# Access Compliance Report

## Public Rights-of-Way

Intersection ID: 46180	Main Street: SWEETSPIRE_RD	Cross Street: SEVEN_OAKS_DR	Location: E
ADA ID: D6E436D973EC	Ramp Type: PerpDiag	Initial Pass/Fail: Fail	Overall Compliance: No
		Severity Score: 10

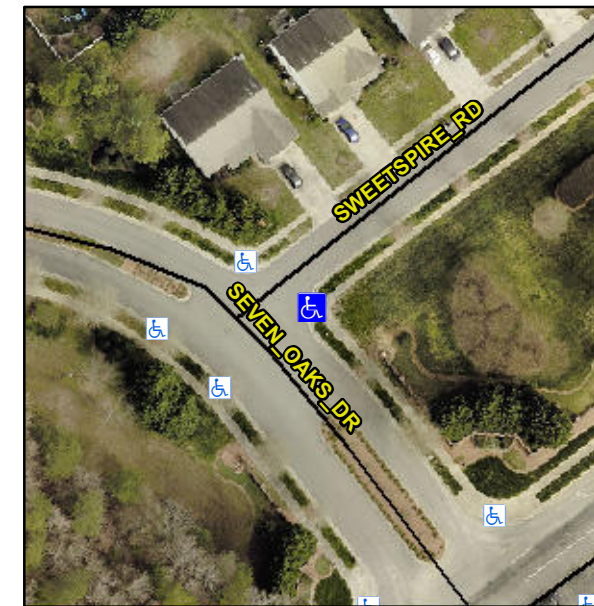
**Not Found, R304.5.1, R304.5.3**

Compliance	Description	Data	Compliance	Description	Data
N/A	Ramp Length (in)	59.5	Yes	Ramp Slope (%)	5.2
No	Ramp Width (in)	47.0	No	Ramp XSlope (%)	2.8
N/A	Flare Type LT	N/A	N/A	Flare Type RT	N/A
N/A	Flare Slope LT (%)	N/A	N/A	Flare Slope RT (%)	N/A
N/A	Flare Traversable LT?	N/A	N/A	Flare Traversable RT?	N/A
N/A	Landing Length (in)	N/A	N/A	DWS Provided?	N/A
N/A	Landing Width (in)	N/A	N/A	DWS Contrast?	N/A
N/A	Landing Slope (%)	N/A	N/A	DWS Length (in)	N/A
N/A	Landing X Slope (%)	N/A	N/A	DWS Full Width?	N/A
N/A	Landing Curb? (Y/N)	N/A	N/A	DWS Offset (in)	N/A
N/A	Shared Landing?	N/A			
N/A	Gutter Ponding?	N/A	N/A	Gutter Slope (%)	N/A
N/A	Gutter Lip Ht (in)	N/A	N/A	Gutter X Slope (%)	N/A
N/A	Painted X Walk1?	No	N/A	Painted X Walk2?	No
	X Walk 1 Direction	To NW		X Walk 2 Direction	To SW
N/A	X Walk 1 Width (in)	N/A	N/A	X Walk 2 Width (in)	N/A
	X Walk 1 Slope (%)	0.7		X Walk 2 Slope (%)	3.1
	X Walk 1 X Slope (%)	1.5		X Walk 2 X Slope (%)	1.3

**Remove & Replace Curb Ramp With Two New Directional Ramps or Equivalent.**
